From: Foss, Dyan
Sent: Tuesday, August 26, 2003 5:40 PM
To: Gilbreath, Chris; Brothers, James; Denise Onyskiw (E-mail); Jerry Henderson (E-mail); Melissa Anderson (E-mail); Shirley Garcia (E-mail); Gunderson, Steve; Rehder, Timothy; Albert Nelson (E-mail); Schneider, John
Cc: Robbins, Jan; Shelton, Dave; Zarret, Joel
Subject: 771 DOP

The Building 771 DOP, Major Modification 5, was approved by CDPHE yesterday, August 25. I appreciate all the time everyone took in commenting on the document and sitting down with me to go over those comments. Thank you!

**771 Closure Project
Decommissioning Operations Plan
Modification 5**

August 8, 2003

Figure 4. Building 771 First Floor Plan Demolition Concept

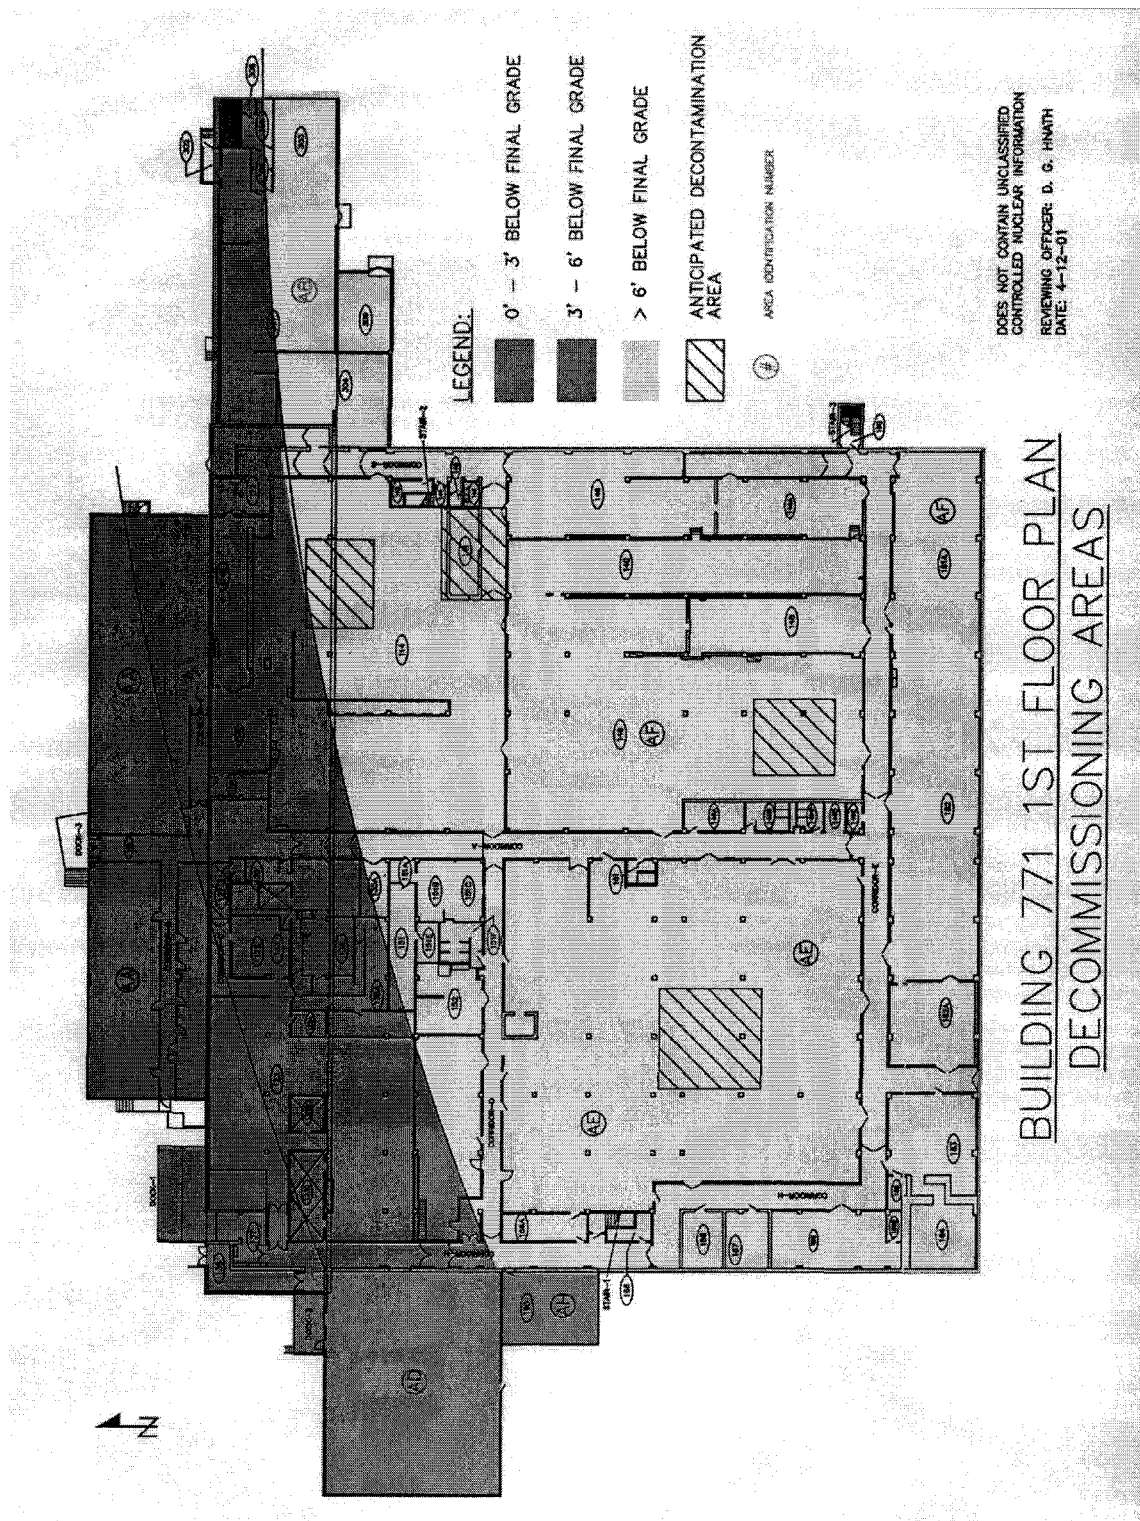
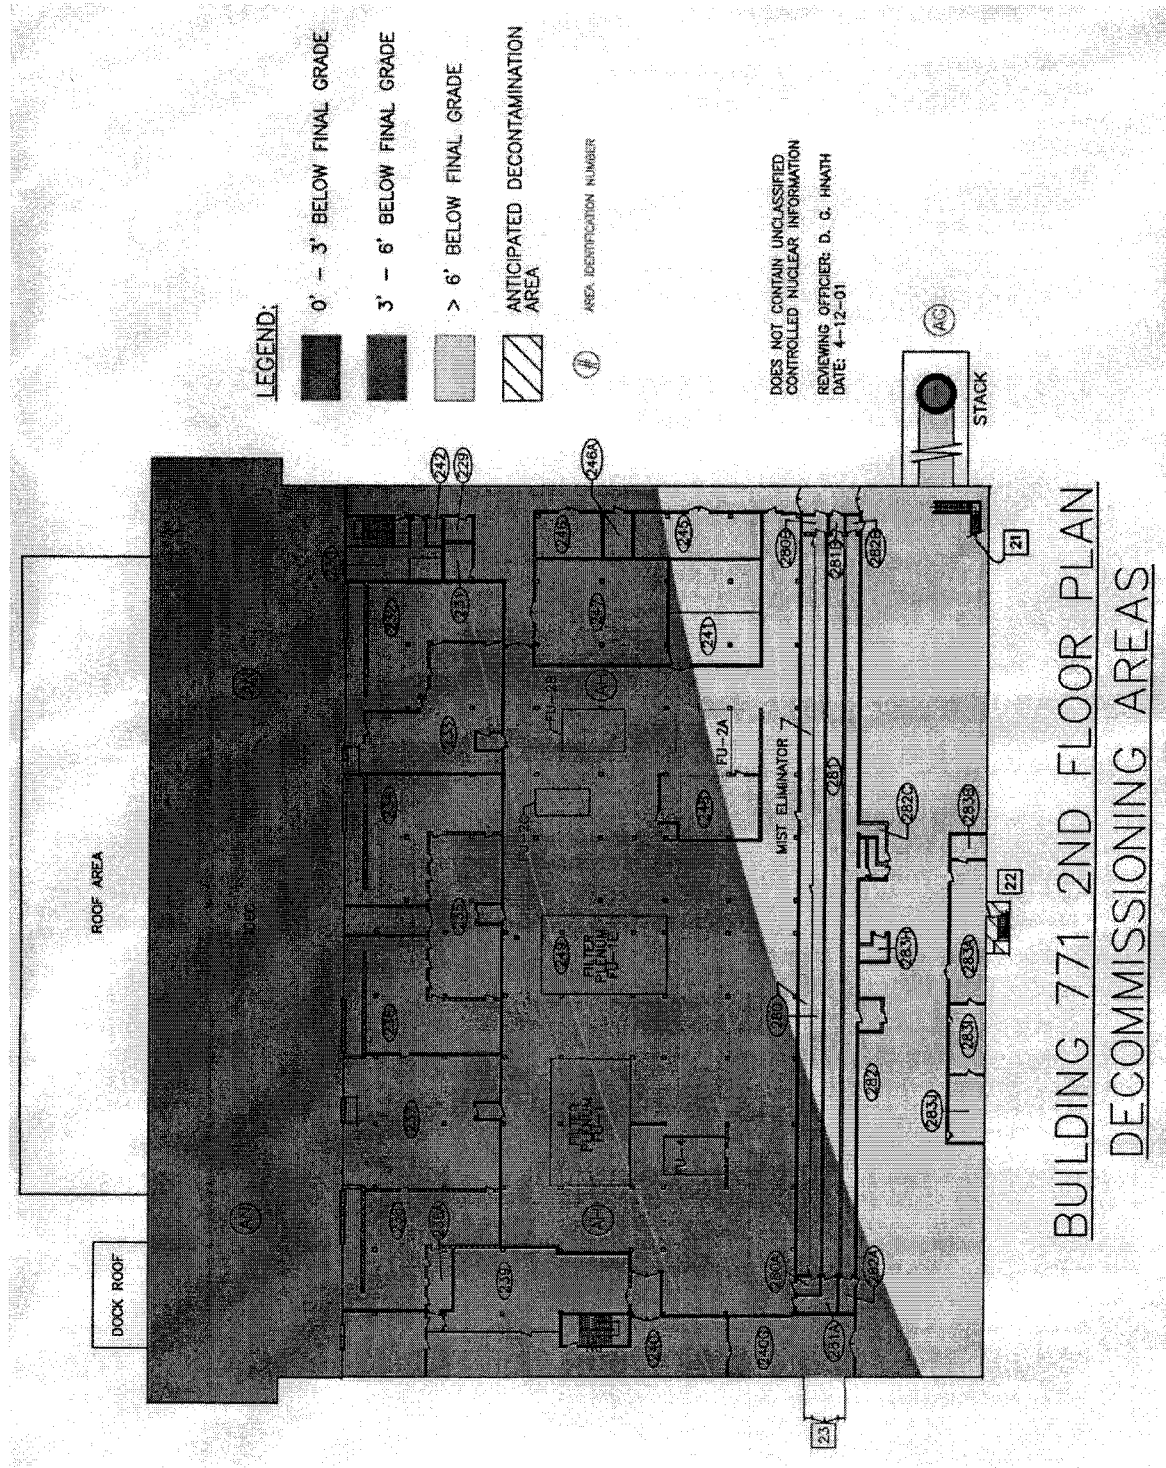
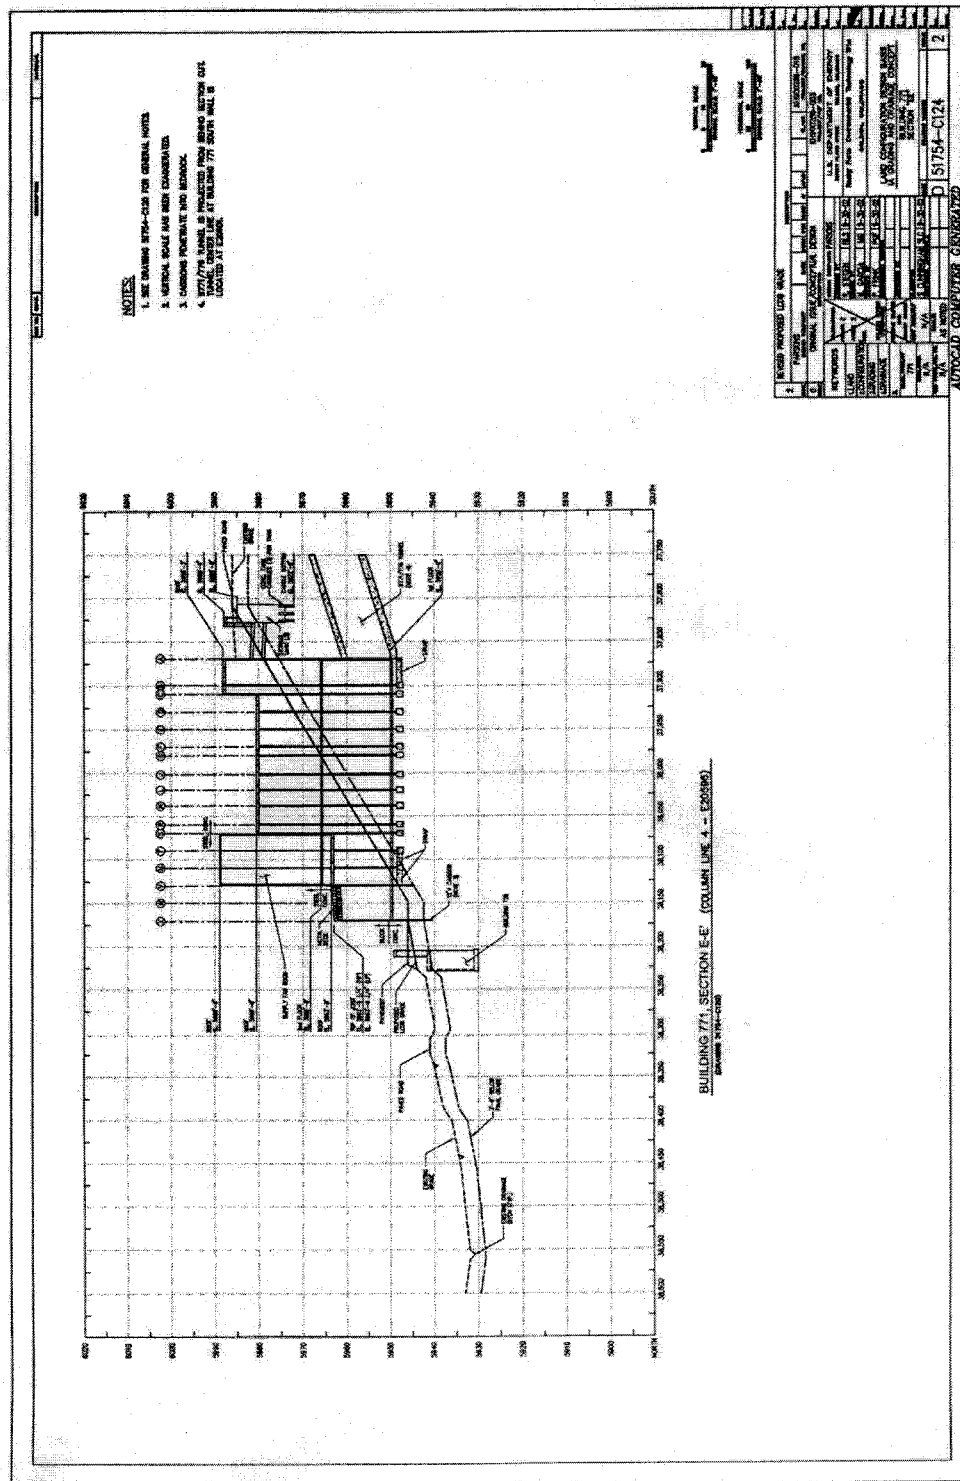
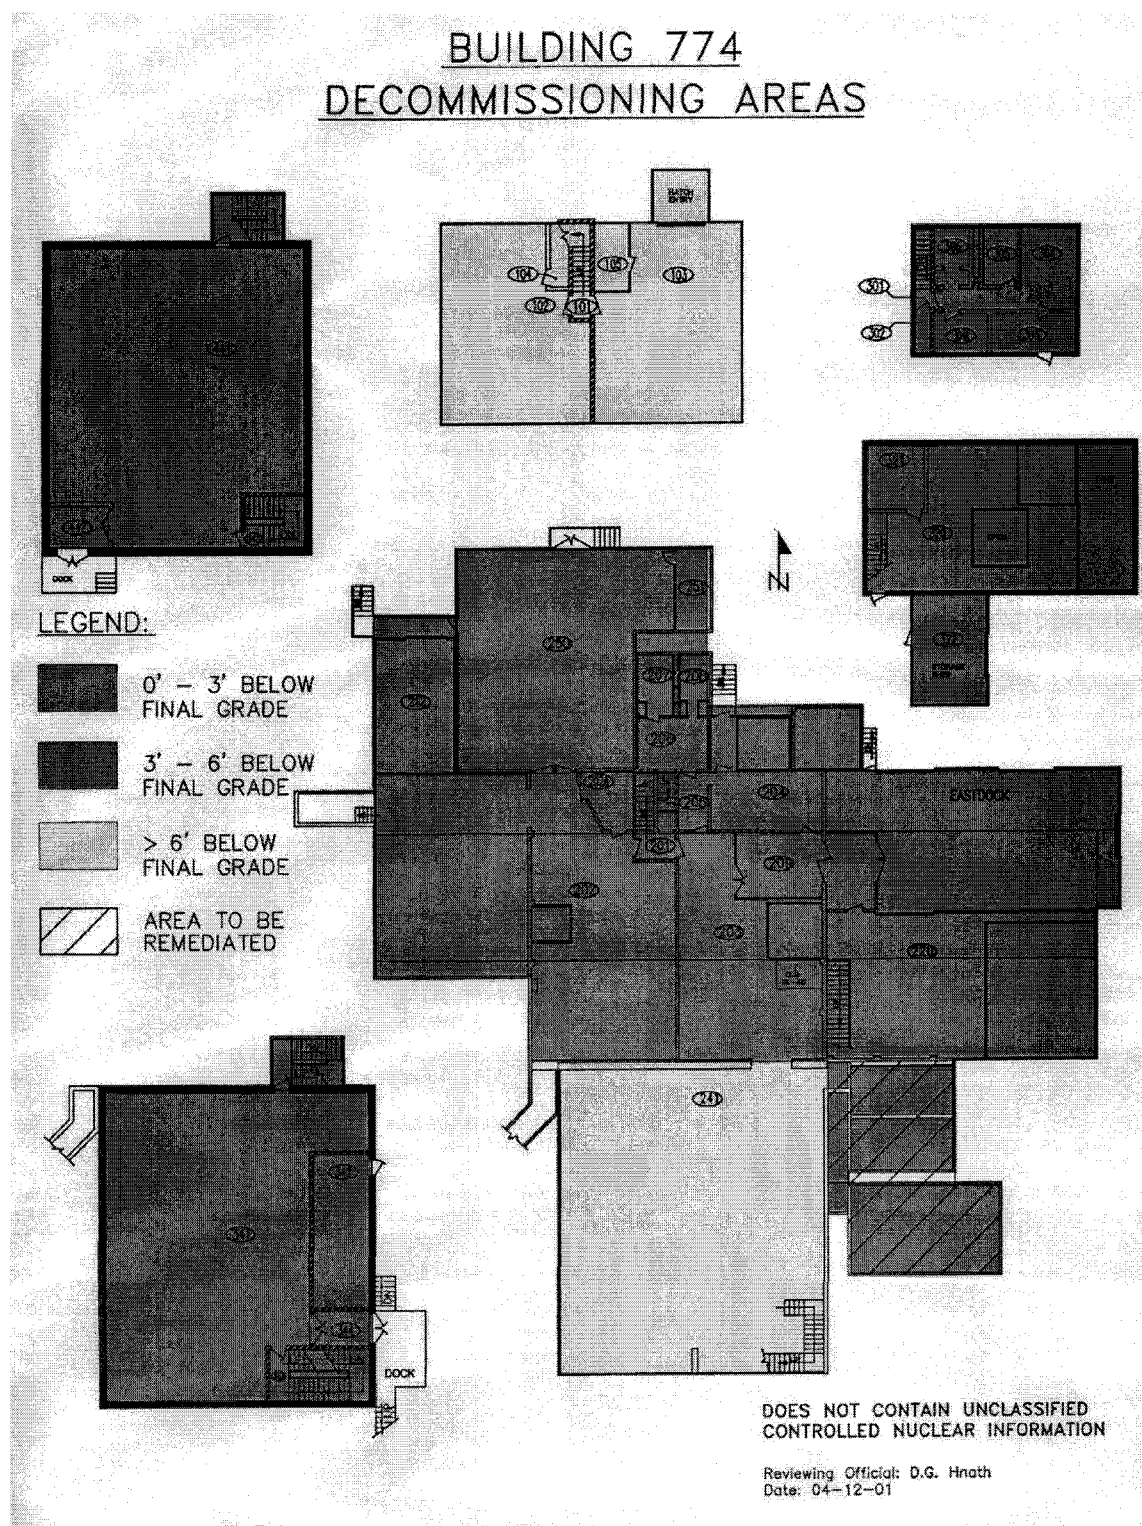
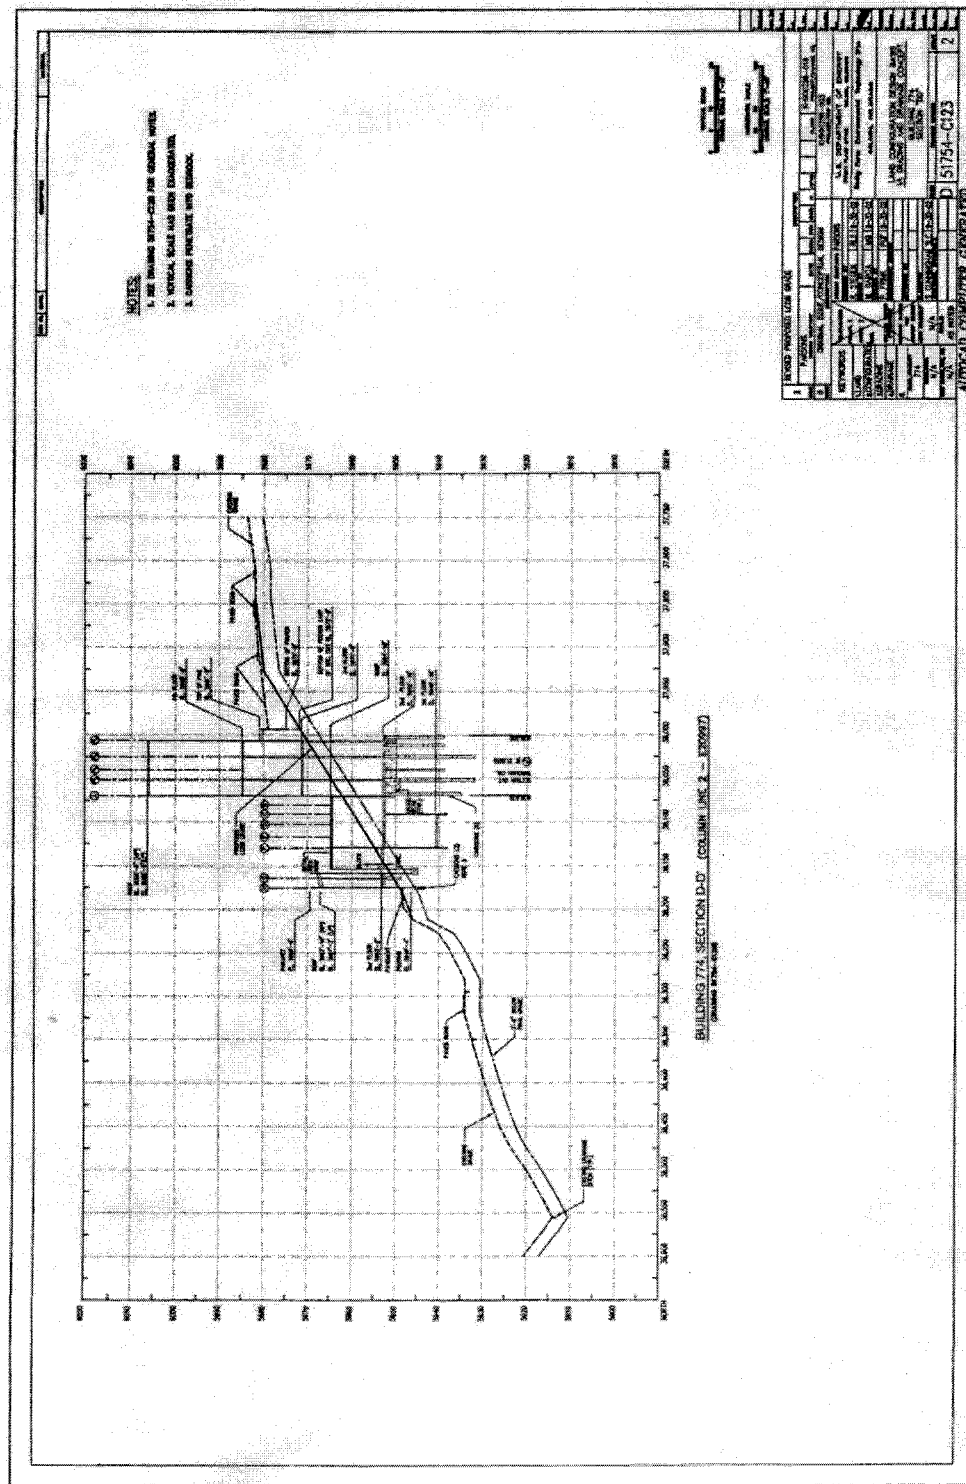
5	<p>Figures</p> <p>The text in Section 4.7.1.8 (Demolition of the Main Building 771 Structure) describes the planned three-sided configuration for the Building 771 foundation area after demolition, and states that "Figures 4 and 5 provide an aerial view of this concept." Figures 4 and 5 provide a useful aerial view, but they do not show the three-sided configuration referenced. During the Coalition staff briefings, Site representatives distributed side-view diagrams of the post-demolition condition of B771 and B774. It would be helpful to include these diagrams so that the reader has a better understanding of the depth of the buildings and how much of the structures will be demolished.</p>	<p>These figures were added to the document.</p>
